EA Project No.: 16-1100

DATE OF ISSUANCE: February 14, 2017

Notice: This addendum is issued to all prospective bidders as an amendment to the Drawings and Project Manual for the Canopy Row. Bidders shall acknowledge this addendum on the Bid Form. All information contained herein shall be fully incorporated into the Contract Documents as though originally included therein.

A762

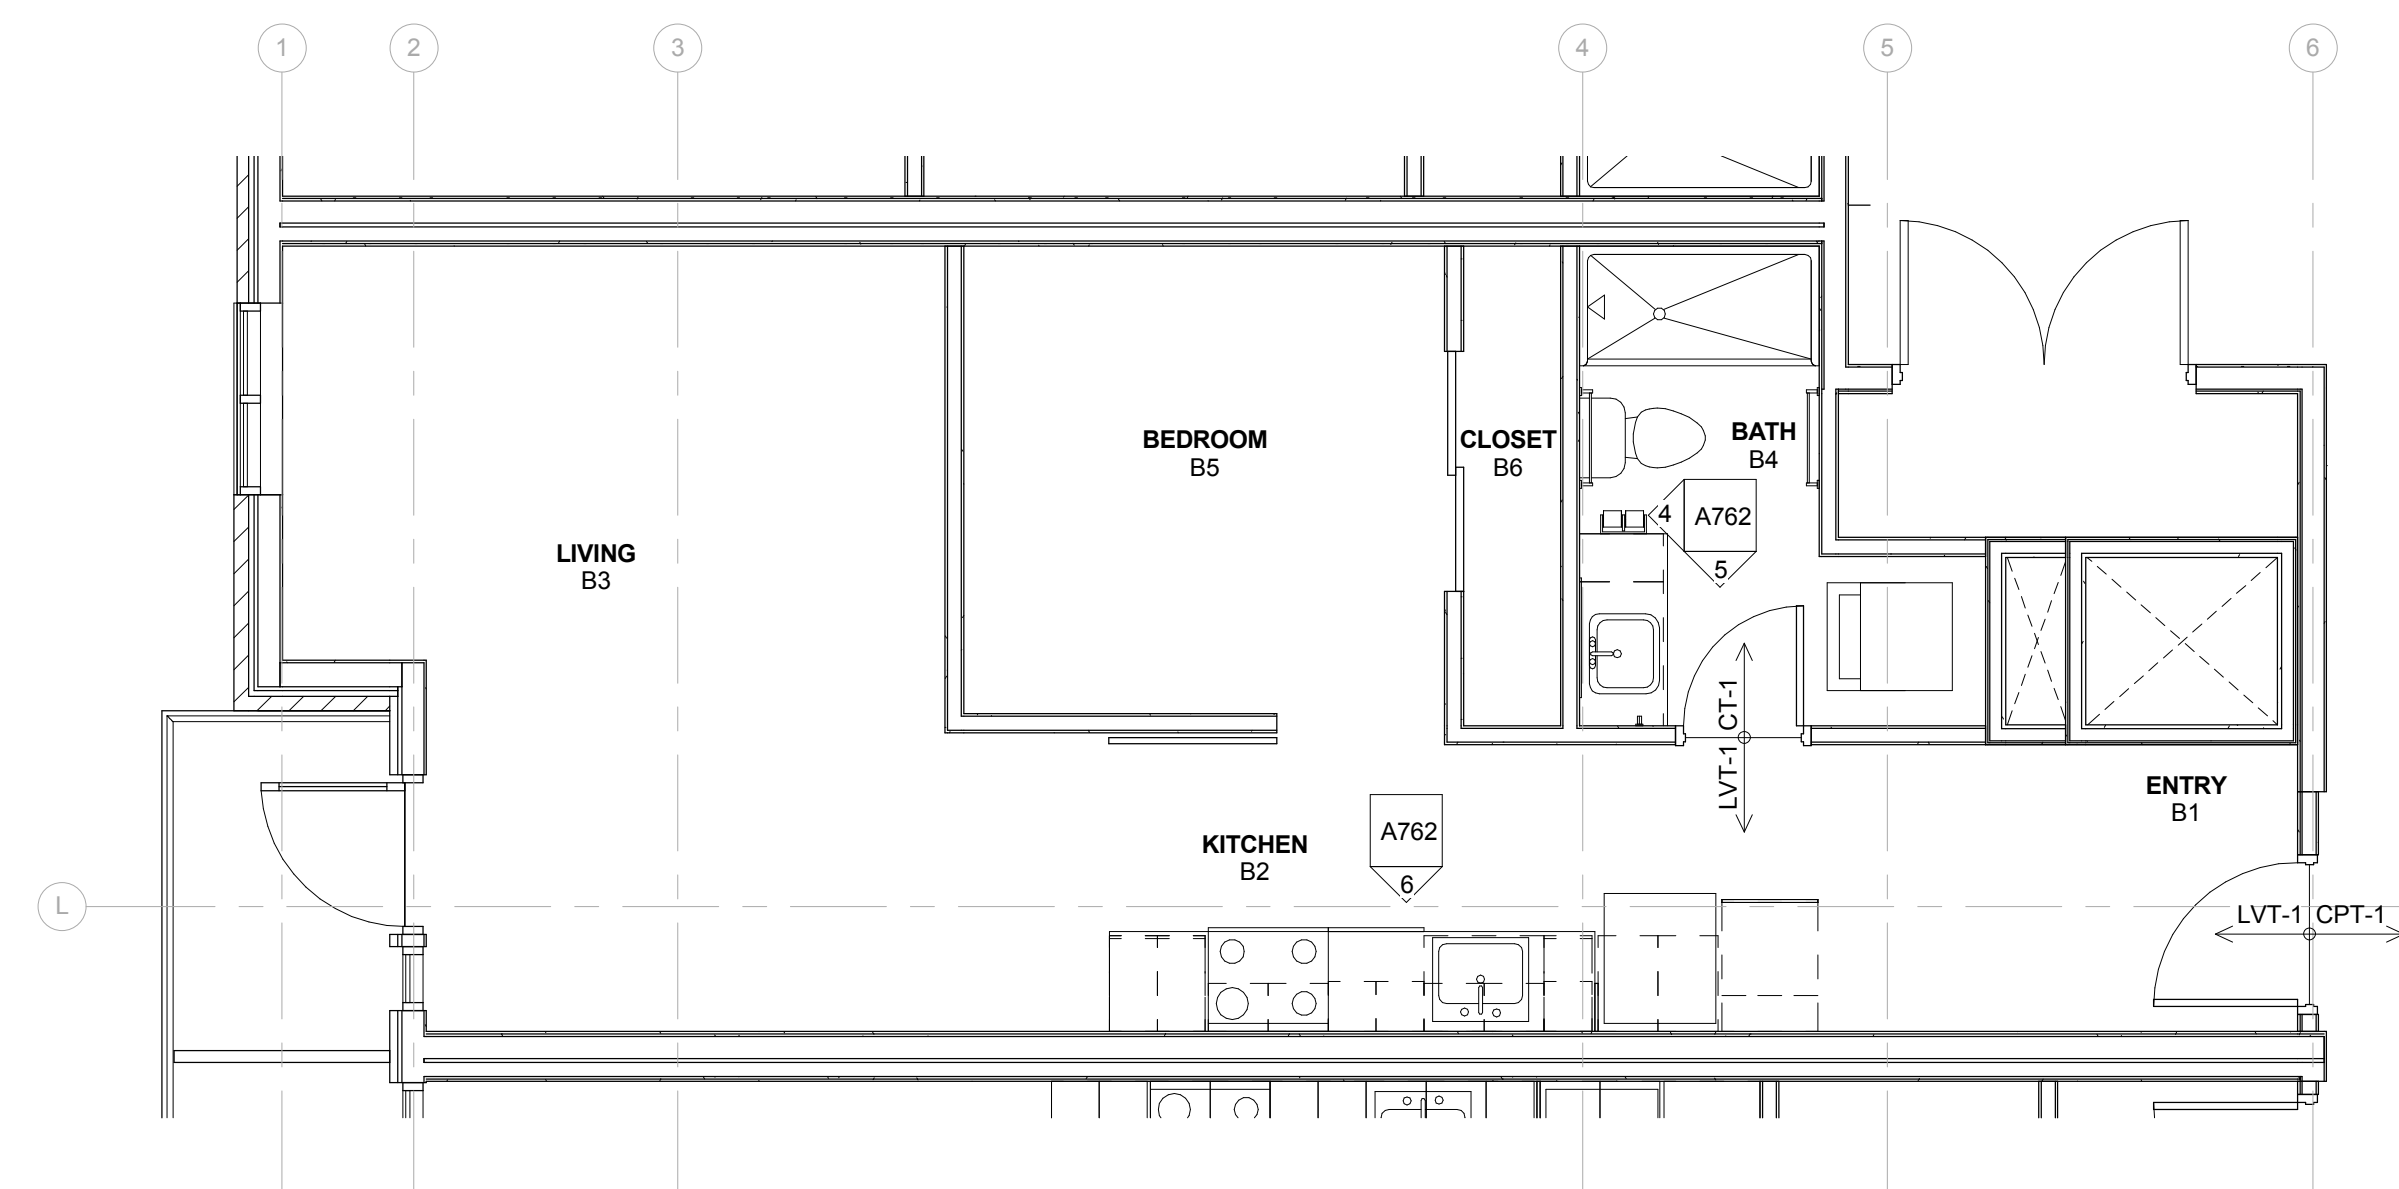
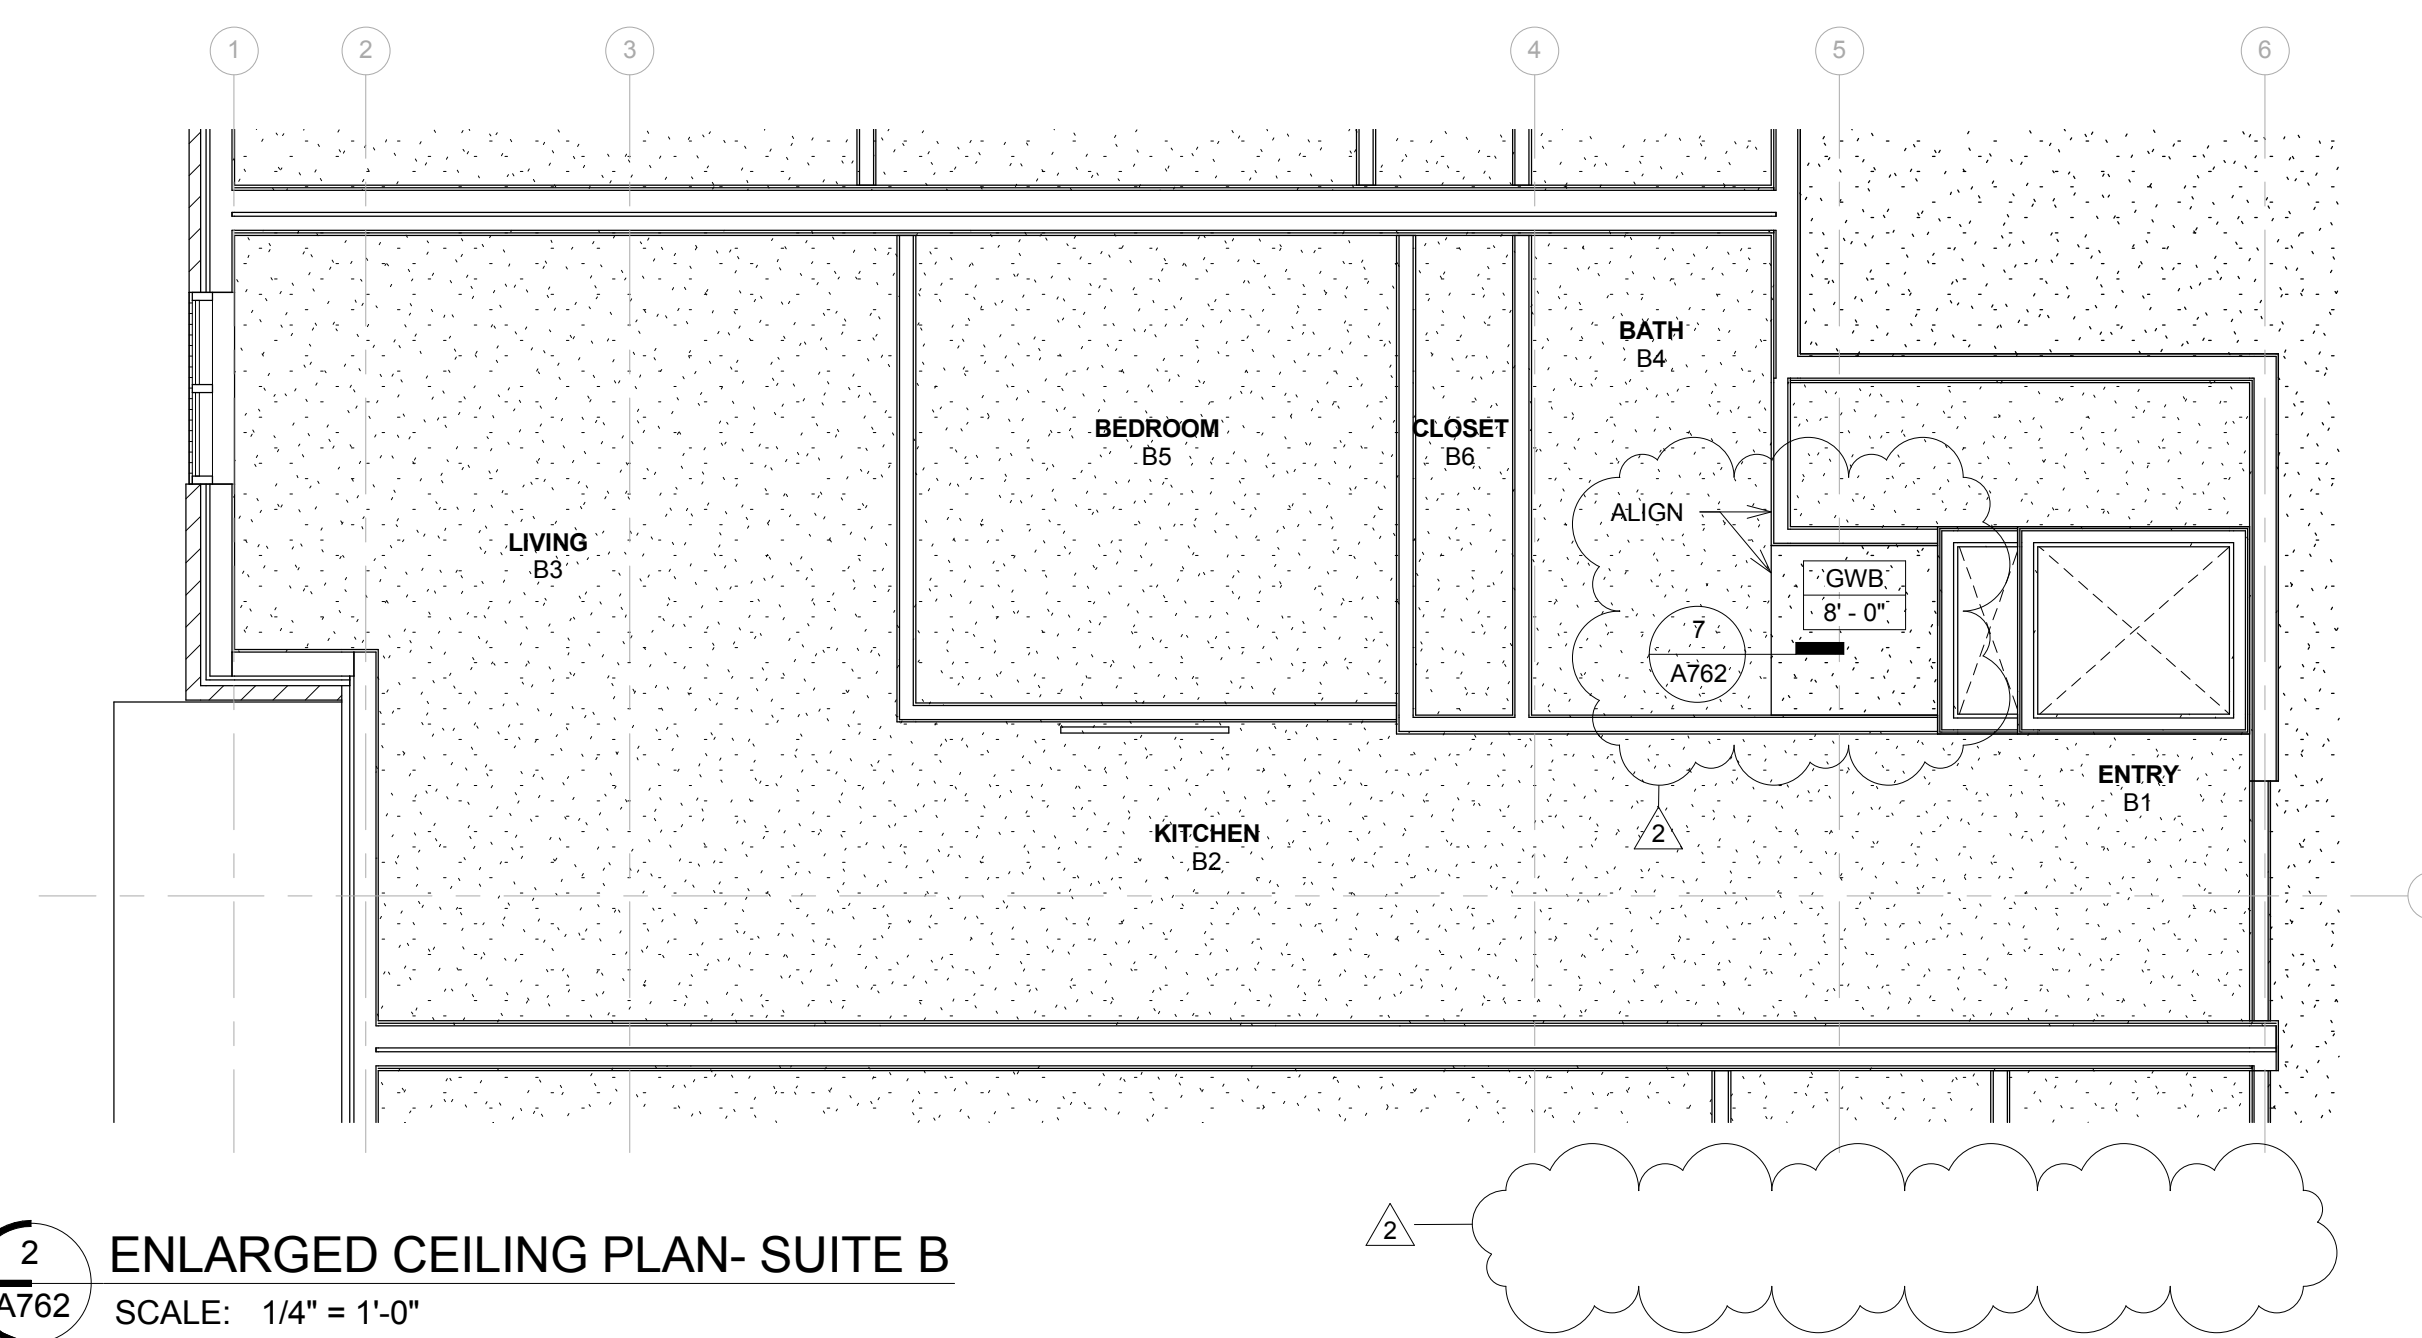
- Item AD-14. Sheet A761 – Suite A
 - a. Revise details 2/A761 as indicated on attached sheet A761.
- Item AD-15. Sheet A762 – Suite B
 - a. Revise details 2/A762 and add detail 7/A762 as indicated on attached sheet A762.

2 ENLARGED CEILING PLAN- SUITE C
SCALE: 1/4" = 1'-0"

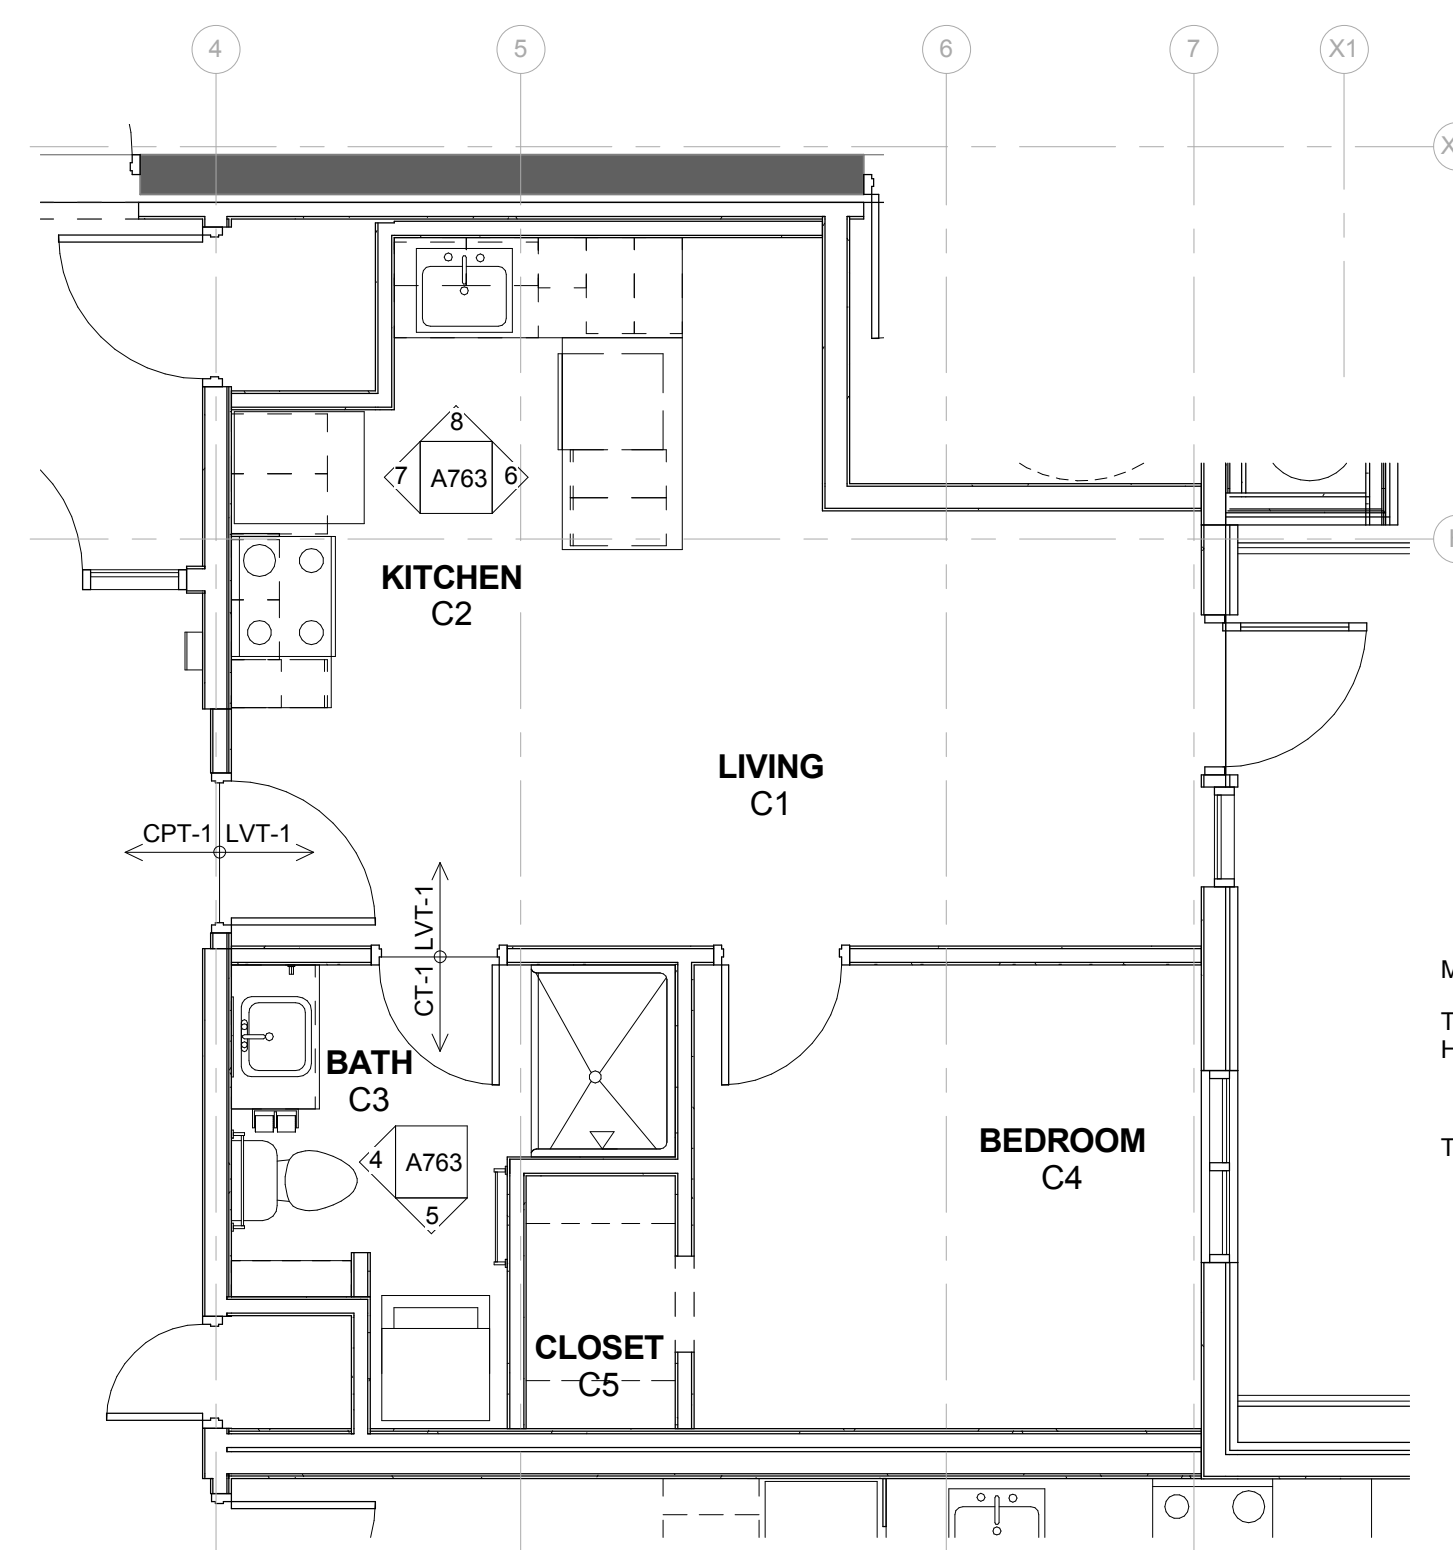
- Item AD-16. Sheet A763 – Suite C
 - a. Revise details 2/A763 as indicated on attached sheet A763.
- Item AD-17. Sheet A764 – Suite D
 - a. Revise details 2/A764 as indicated on attached sheet A764.
